# Access Compliance Report

## Public Rights-of-Way

### (Curb Ramps)

Intersection ID: 12711	Main Street: E_STONEWALL_ST	Cross Street: S_TRYON_ST	Location: E
ADA ID: 27CC271C39D8	Ramp Type: Perp	Initial Pass/Fail: Fail	Overall Compliance: No
			Severity Score: 13.75

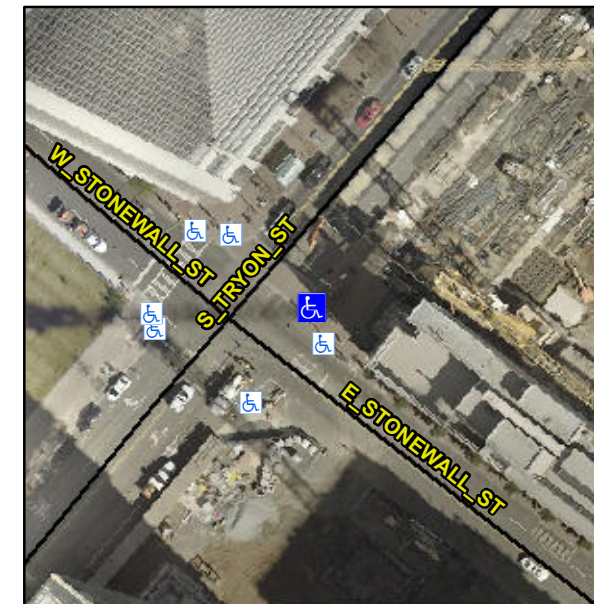
**R304.2.2, R304.5.3**

Compliance	Description	Data	Compliance	Description	Data
N/A	Ramp Length (in)	43.0	No	Ramp Slope (%)	11.1
Yes	Ramp Width (in)	60.0	No	Ramp XSlope (%)	2.3
N/A	Flare Type LT	N/A	N/A	Flare Type RT	N/A
N/A	Flare Slope LT (%)	N/A	N/A	Flare Slope RT (%)	N/A
N/A	Flare Traversable LT?	N/A	N/A	Flare Traversable RT?	N/A
N/A	Landing Length (in)	N/A	N/A	DWS Provided?	N/A
N/A	Landing Width (in)	N/A	N/A	DWS Contrast?	N/A
N/A	Landing Slope (%)	N/A	N/A	DWS Length (in)	N/A
N/A	Landing X Slope (%)	N/A	N/A	DWS Full Width?	N/A
N/A	Landing Curb? (Y/N)	N/A	N/A	DWS Offset (in)	N/A
N/A	Shared Landing?	N/A			
N/A	Gutter Ponding?	N/A	N/A	Gutter Slope (%)	N/A
N/A	Gutter Lip Ht (in)	N/A	N/A	Gutter X Slope (%)	N/A
N/A	Painted X Walk1?	Yes	N/A	Painted X Walk2?	N/A
	X Walk 1 Direction	To NW		X Walk 2 Direction	N/A
N/A	X Walk 1 Width (in)	145.0	N/A	X Walk 2 Width (in)	N/A
	X Walk 1 Slope (%)	6.4		X Walk 2 Slope (%)	N/A
	X Walk 1 X Slope (%)	1.2		X Walk 2 X Slope (%)	N/A

**Remove & Replace Entire Ramp.**
